SUBJECT: Calvert Cliffs Nuclear Power Plant
Unit Nos. 1 & 2; Docket Nos. 50-317 & 50-318
Request for Additional Information: Supplemental Response to Generic
Letter 2004-02, Potential Impact of Debris Blockage on Emergency
Recirculation during Design Basis Accidents at Pressurized Water Reactors

REQUEST FOR ADDITIONAL INFORMATION: GENERIC LETTER 2004-02

Figure 11-1. Coatings Transport Test Results

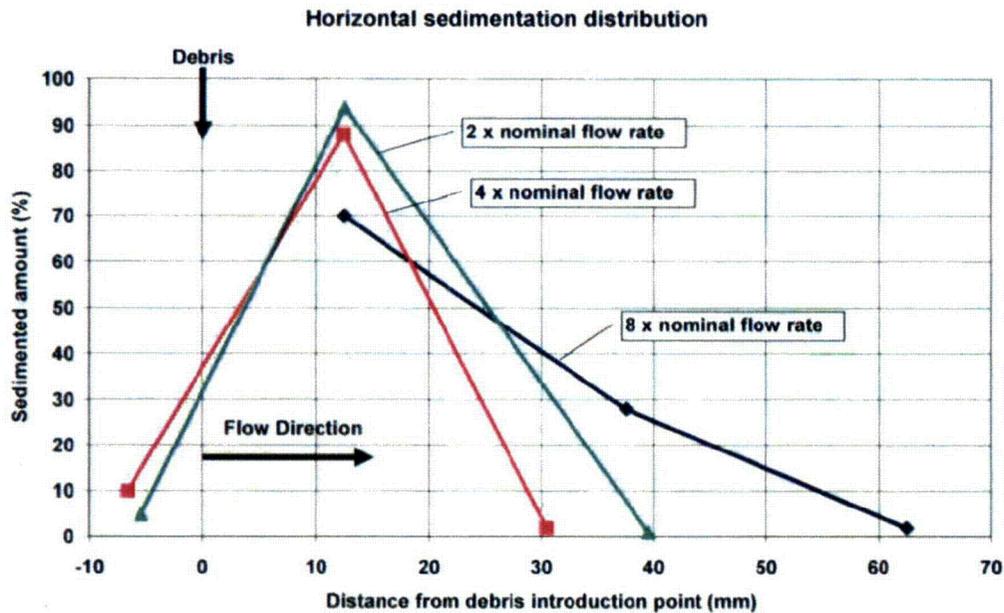
The supplemental responses indicates that, while a computational fluid dynamics analysis of the containment pool during recirculation was not performed, coating chips were observed to fall to the flume floor during head loss testing. Therefore, a lack of transportability for coatings was assumed in the containment pool, and the NUREG/CR-6916 results were assumed to be applicable to Calvert Cliffs. Please identify the size range of the coating chips that were tested and provide a basis for considering the fluid velocity and turbulence in the head loss test flume as being similar to the range of values expected in the Calvert Cliffs containment pool. This will enable the NRC staff to evaluate the technical basis and methodology used to derive the unqualified coating transport fraction of 0.0624.

The test of transportability of coatings chips used coating chips size distribution of 1-4 mm.

Results of transport test for these coating chips are provided in Figure 11-1 below. These results show that at high flow rates, 8 times nominal, average transport is well under 1 meter (40 inches) from the introduction point for the entire depth of the containment pool. Therefore, the test flow rates were much greater than expected in the plant post-LOCA. Corresponding turbulence levels were not measured nor are they calculated for the plant. Transport distances are negligible for the size of the containment at Calvert Cliffs.

Figure 16-1. Head Loss Test Results Including Chemical Effects Specific for STB Buffer

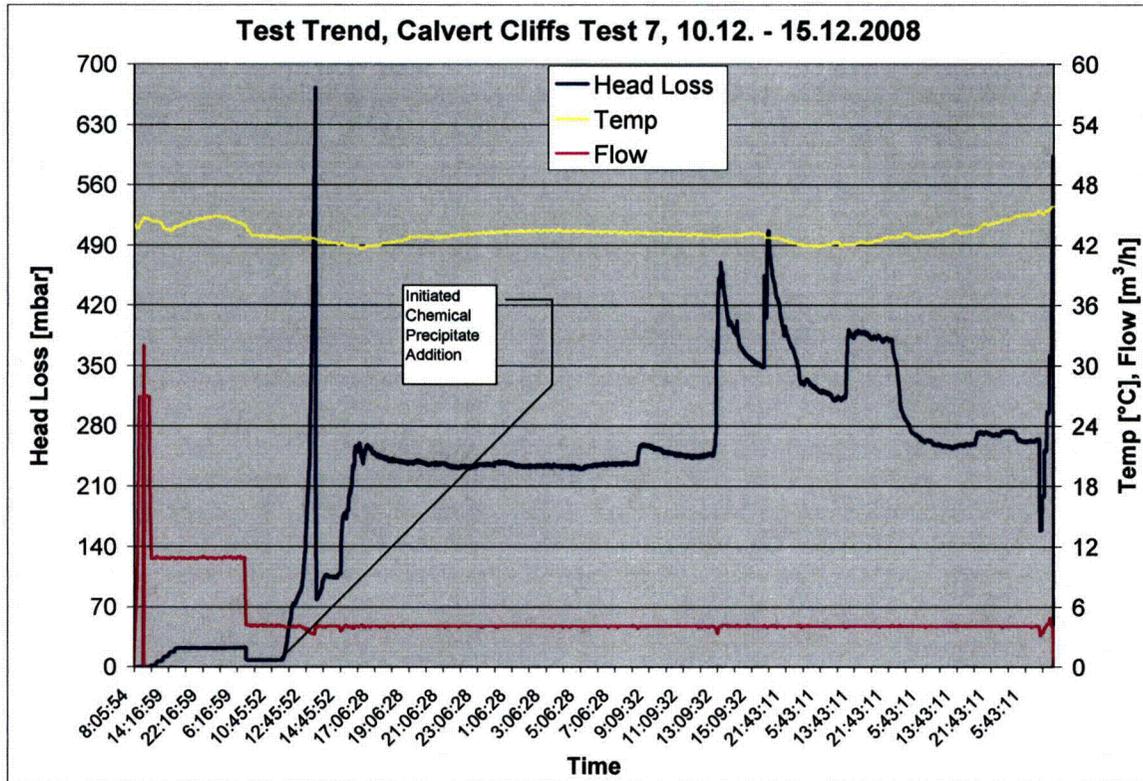
Please provide the results and methodology for the final strainer qualification testing for head loss and vortexing with a level of detail consistent with the information requested in the NRC staff's content guide for supplemental responses. The staff will review this information when the licensee submits it, and as a result of such review, the staff could request additional information in this subject area if needed.

The abbreviated procedure for performance of the tests is provided below. The results for one of the tests, specific to use of sodium tetraborate decahydrate (STB), is provided. Maximum head loss observed was nearly 700 millibar and is used as the design head loss across the strainer for debris laden conditions, including chemical effects. Initial flow rates are nearly 700% of the nominal and provide (along with additional non plant-specific CCI vendor test data) a clear basis supporting no vortex formation. Flow sweeps are performed at the conclusion of the test to demonstrate stability of the bed.

Note: Agitation performed at about 13:00, 18:00 Day 2 and about 08:00 Day 3.

Figure 27-1. Cross-section of Containment

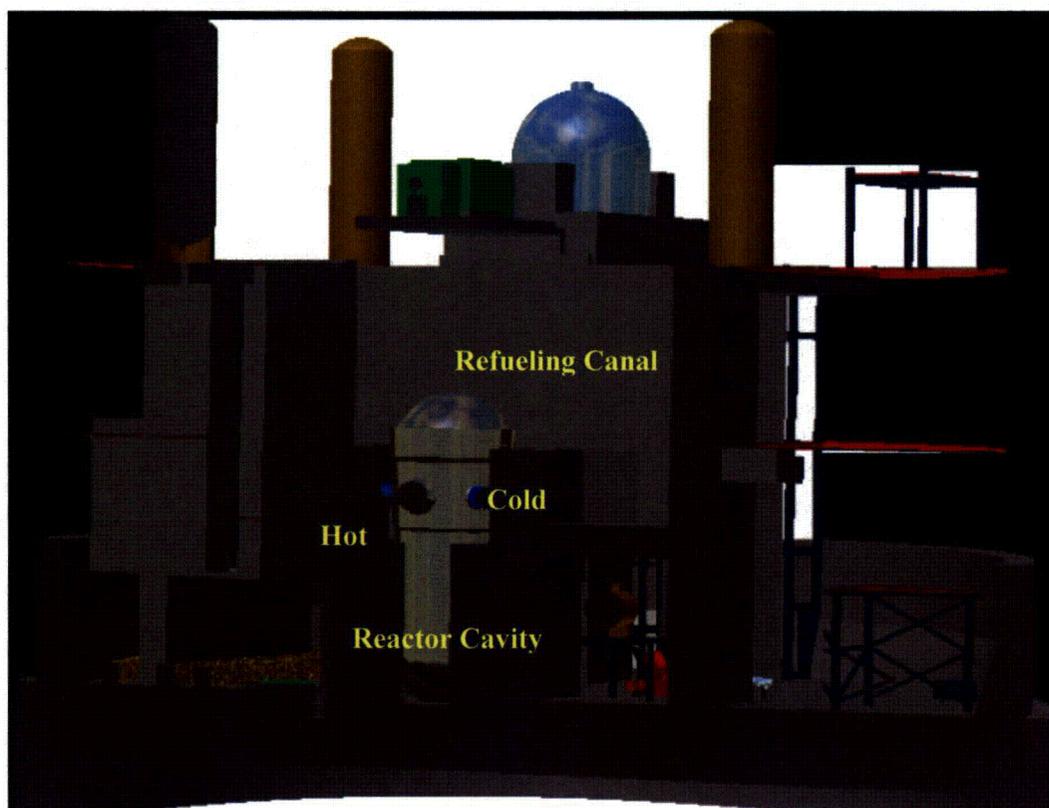
The supplemental response dated September 30, 2008, indicates that two refueling pool compartments could retain water up to the level of the refueling pool seal ring since the drain to these compartments is a 1-inch drain. Once the water level reaches the level of the seal ring, the response notes that water

would spill into the reactor cavity. The response indicates that the reactor cavity is drained through a 2-inch pipe that contains a valve. The supplemental response did not provide adequate basis to conclude that debris washed down by spray drainage (which could include reflective metallic insulation, fiber, particulate, foreign materials, etc.) would be precluded from blocking the drains to the refueling pool compartments or the reactor cavity. Instead, a water volume of 3,792 ft³ was assumed to be trapped in the reactor cavity and an unspecified volume of water was assumed to be trapped in the refueling pool below the seal ring elevation. However, based on the information in the supplemental response, the staff noted that, if the refueling pool and reactor cavity drains (or drain valve) become blocked and the reactor cavity fills with water, it is unclear that additional water would not subsequently be held up in the refueling pool in excess of the quantity assumed by the licensee to be retained in the two compartments below the seal ring elevation. Please provide adequate technical basis to demonstrate that the assumed quantity of water hold up for the refueling pool is conservative.

The flow path is water from the Containment Spray System is sprayed from the containment dome area and falls into the refueling canals. The canals then overflow to the reactor cavity since the drains are very small and assumed to be clogged with debris. The reactor cavity fills since it has a 4-inch drain that drains to the normal containment sump through a 2-inch drain line with a 2-inch valve that is also assumed to become clogged. The water spilling from the refueling canals flows down into the reactor cavity through the hatches or doors in the permanently installed seal between the reactor upper flange and the reactor cavity wall. When the cavity water level reaches the hot leg penetration, increasing water then spills out into the pump bays and hence to the 10 foot level and the recirculation pool. There is about 6 inches of clearance between the hot leg penetration and the hot leg so there is adequate flow passage to prevent additional filling to occur. See Figures 27-1 and 27-2 below.

Figure 31-1. Test Results for Unit 1 Specific Testing with TSP Conditions

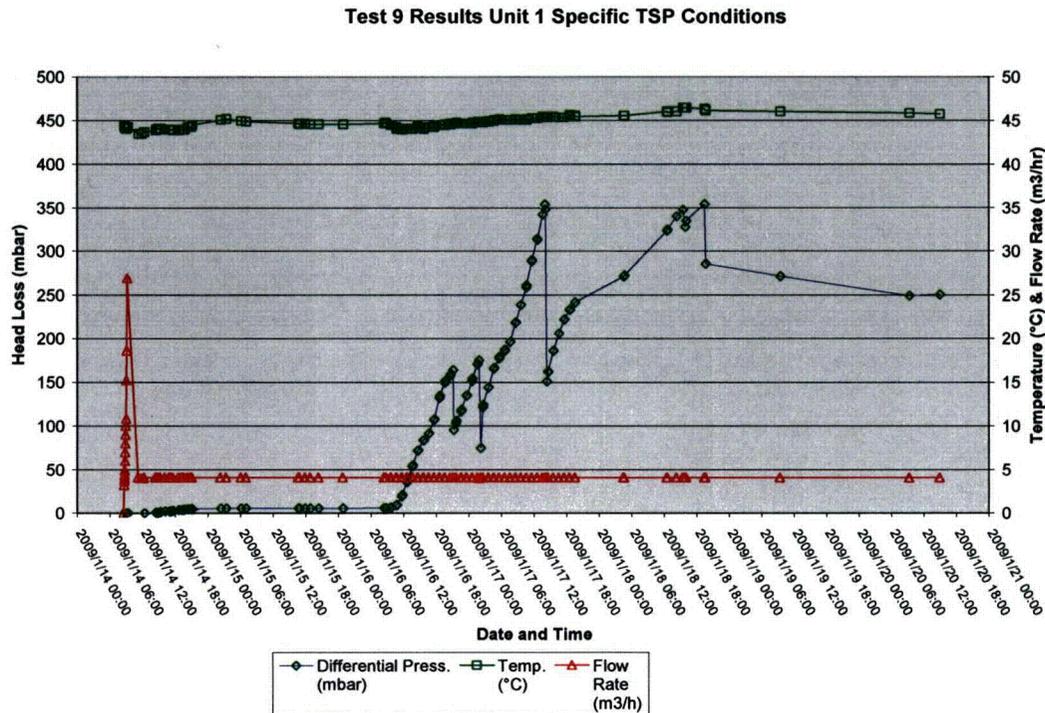
In Attachment 1 to the Constellation letter to the NRC dated June 18, 2008 (ADAMS Accession Number ML081710105), you indicated that Calvert Cliffs may be taking additional actions, such as switching the buffer used for control of pH following a LOCA, that would change potential chemical effects. Therefore, please provide the results (e.g., a head loss plot) from any additional chemical effects testing and analysis that has not been previously provided. Please discuss why the overall plant-specific chemical effects evaluation is conservative.

Additionally, a test specific to the current state of Unit 1, with TSP buffer, was performed in January 2009. The results of that test are provided below. The test design used the aluminum solubility results provided by Alion testing to assume no sodium aluminum silicate precipitate. The test used only calcium phosphate precipitate. These results demonstrate adequate net positive suction head (NPSH) margin early in the post-LOCA period and beyond.

Note: The chemical precipitates addition began on January 16, 2008 slightly before the head loss began increasing.
